RE: Contract #15025 P00
(Silver) Leeds Certified Green Building – Eastern Family Resource Center
9150 Franklin Square Drive, Baltimore, Maryland 21237
Rosedale – District 14 c 6
Job Order No. 249-218-0100-0614

ADDENDUM NO. 9
To All Bidders

ADDENDUM 09

A2.12B.1 PARTIAL FLOOR PLAN -
 LEVEL 2 AREA B

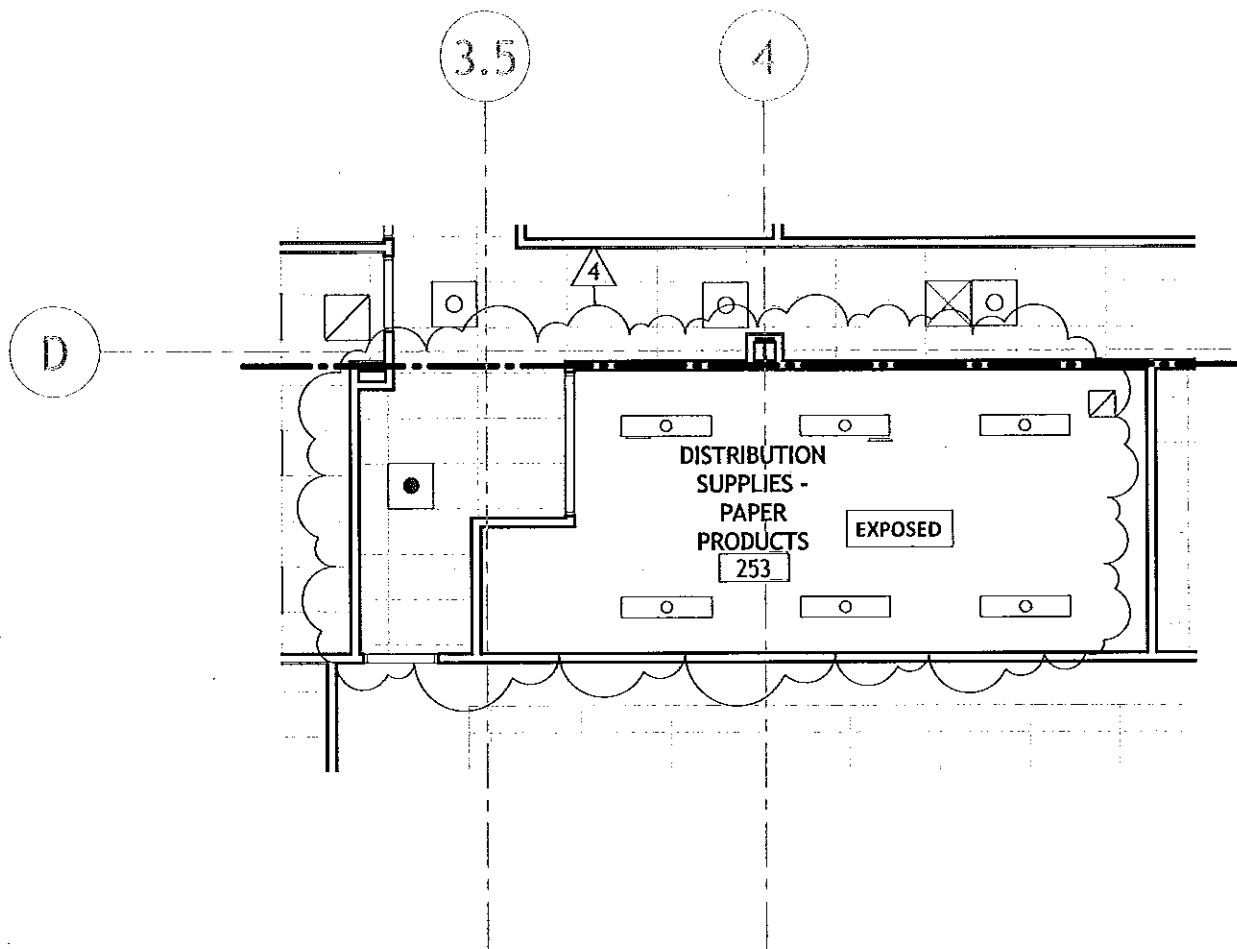
Drawing No.	Change or Clarification
A2.12B.1	Changes associated with relocation of Door 252.
A3.12B.1	Changes associated with relocation of Door 252.
SKS-01	Change to Typical Pier Reinforcing Detail

SHEET DESIGNATION		CONTRACT NO.	
E0.03		15025P00	
		JOB ORDER NO.	
		249-218-0100-0614	
		SHEET 297 OF 359	
		DRAWING NO.	
		2015-1935	
FILE NO.		REV. 03/17	
BKM# 13063.01

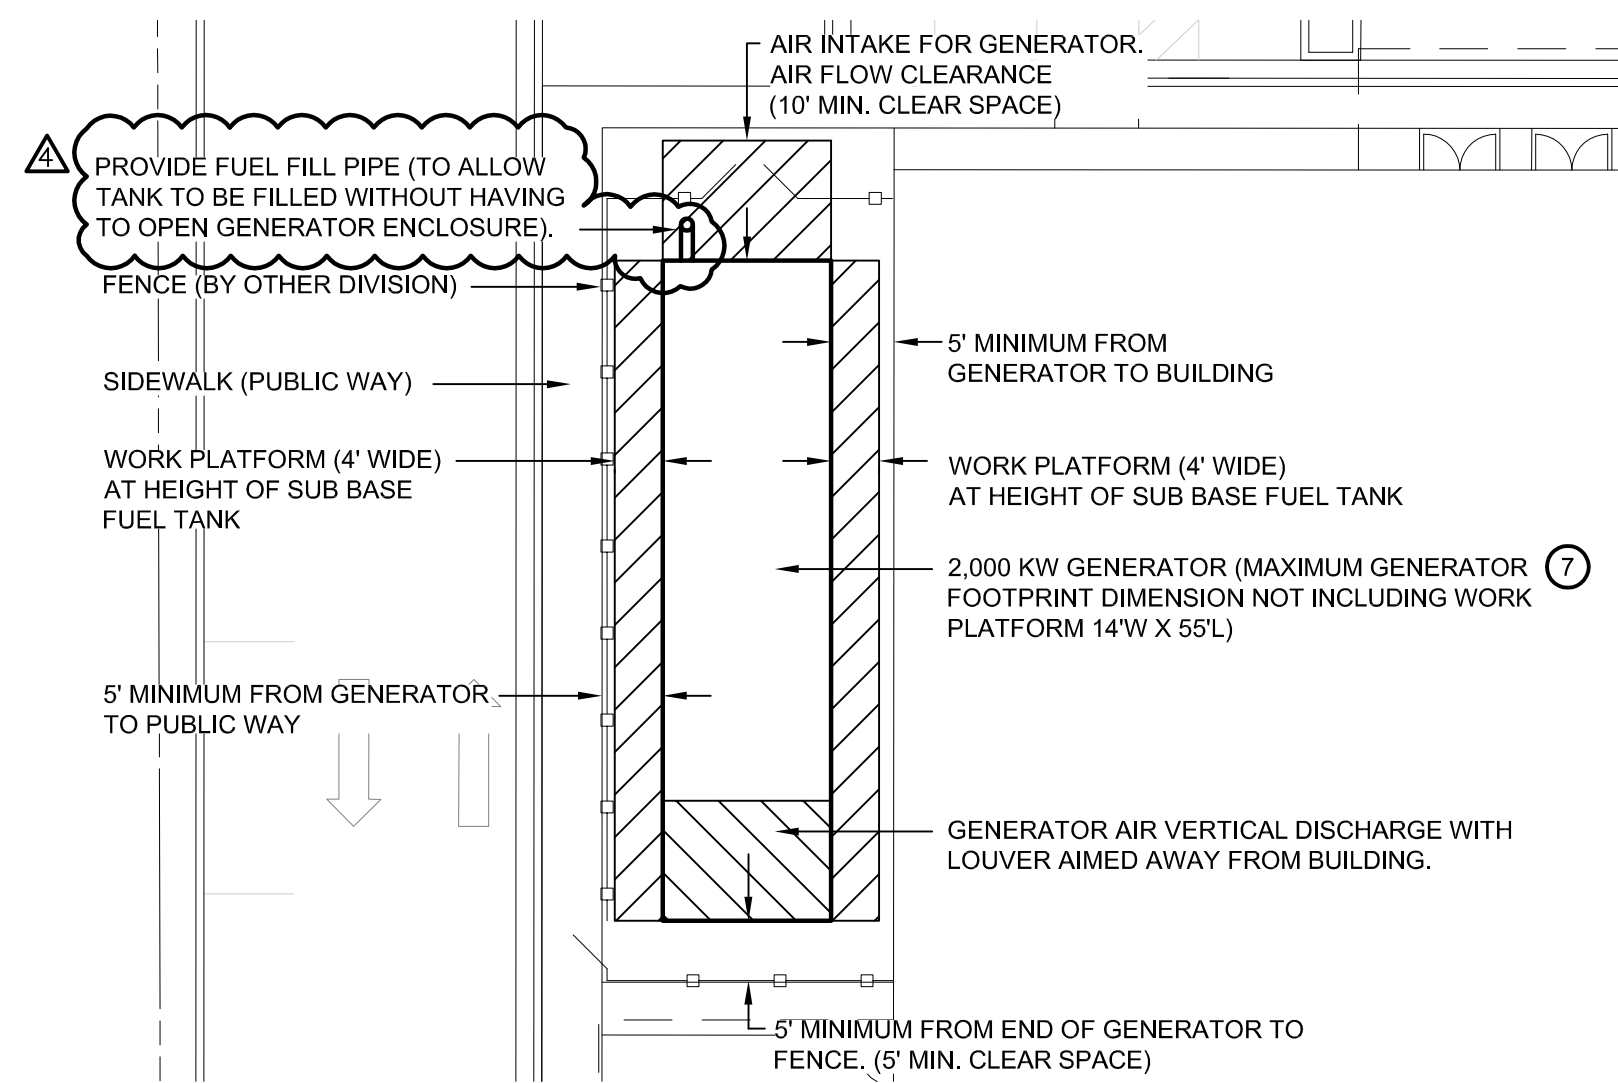
- Q92 The Site print E0.03 and the Tele-Com site print TE1.02 both show the site and appear to be the exact same size. The scales for these 2 are 1" = 40' on the power drawing and 1" = 60' on the tele-com drawing. Which of these scales is correct?

- Q95 Within the specifications it is noted to provide a UL 2085 sub base fuel tank. Is UL 142 Listed acceptable in lieu of the UL 2085?
- A95 Provide UL 2085 fuel tank as specified.

- A87 Direct buried PVC non-concrete encased shall be permitted for exterior underground lighting circuits per drawing notes.
- Q88 Can access control conduits be taken to the cable tray system instead of individual conduit homeruns?

- A92 On sheet TE1.02, change drawing scale to 1" = 40'.
